ASB-1022

## Service Bulletin

**Subject:** MC-44/MC-44DM Intermittent Modulation  
1993

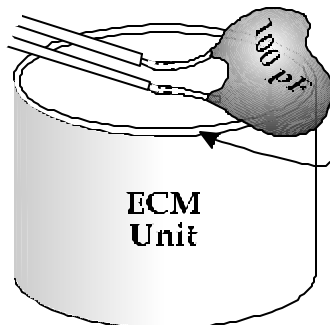
Microphone audio is mechanically intermittent., i.e. striking the microphone will cause audio to be lost or restored.

The lead wire of capacitor C8 might be shorting out against the case of the ECM unit.

Re-install the capacitor so that the leads cannot touch the ECM case.

Make sure the leads of C8 100 pF capacitor do not touch the ECM case.
